Design Exception #3 Reducing the Buffer Area at MP 188 to 190 Design Exception Statement

I-70 West Vail Pass Safety and Operations Improvements

DESIGN EXCEPTION MEETING
AUGUST 2, 2021

DESIGN EXCEPTION FROM MP 188.0 TO 190.1 EB AND WB

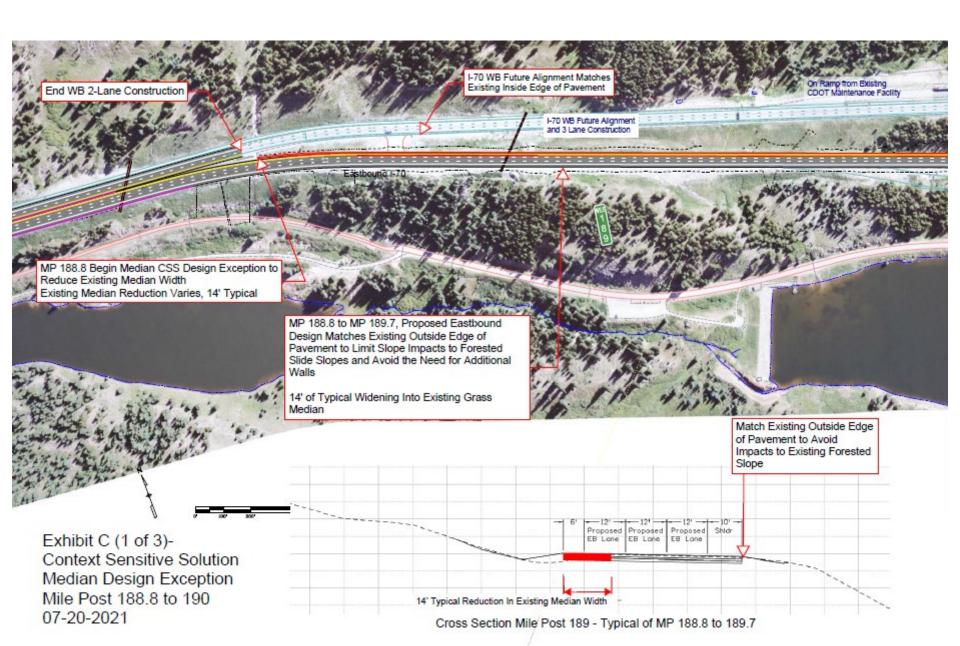
Extending the limits of the design exception to accommodate the aux lane from truck parking to MP190

Matching the existing outside edge of pavement and widening 14' into the median is consistent with the roadway geometry.

This alignment allows the existing truck parking to remain in place.

DESIGN EXCEPTION FROM MP 188.0 TO 190.1

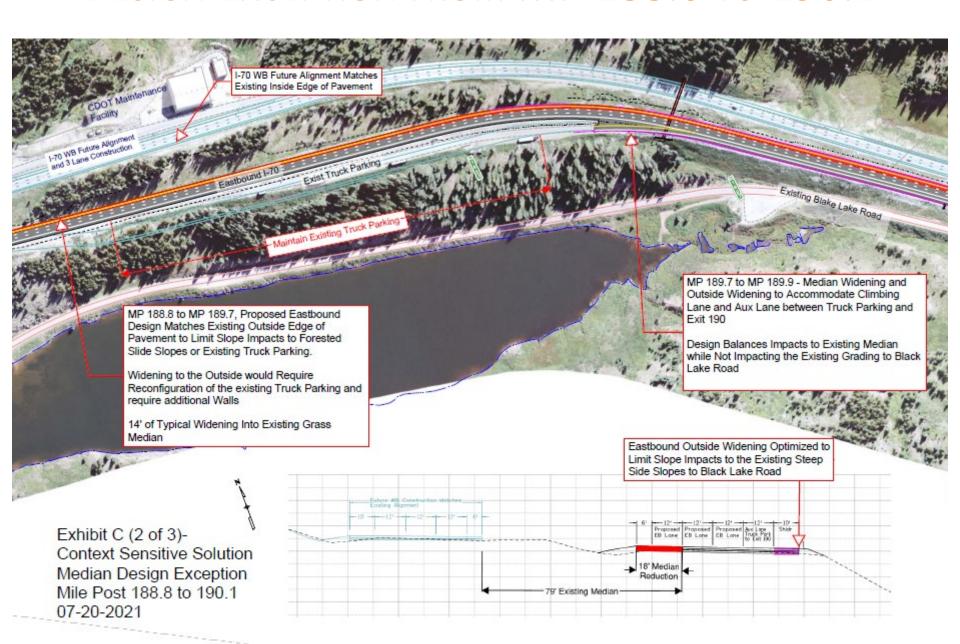
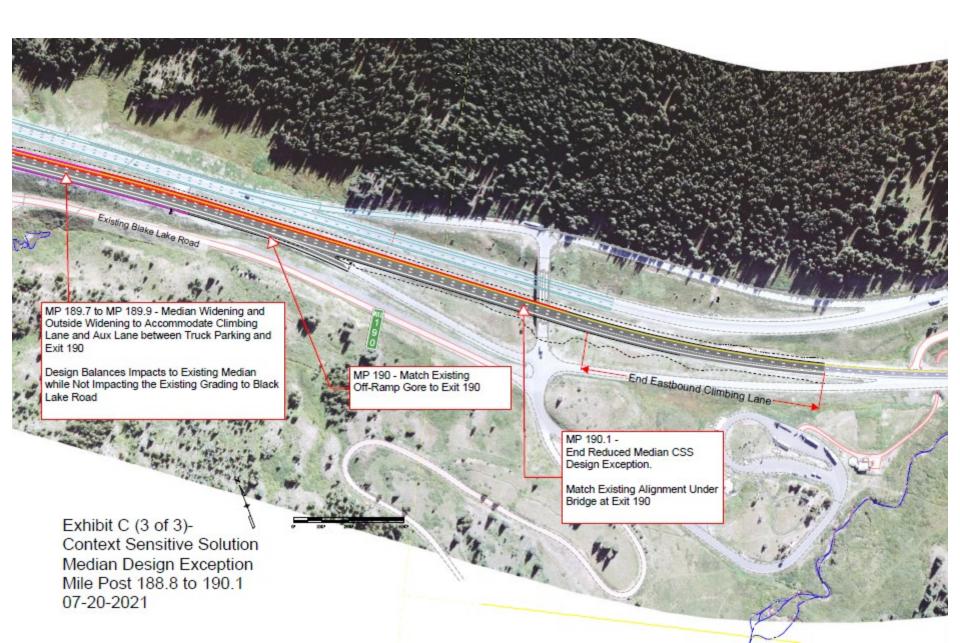
Widening to the south

Widening to the south would push the truck parking toward Black Lake No. 1 and the forested buffer between the parking and lake would be reduced.

This change does not preclude the AGS alignment.
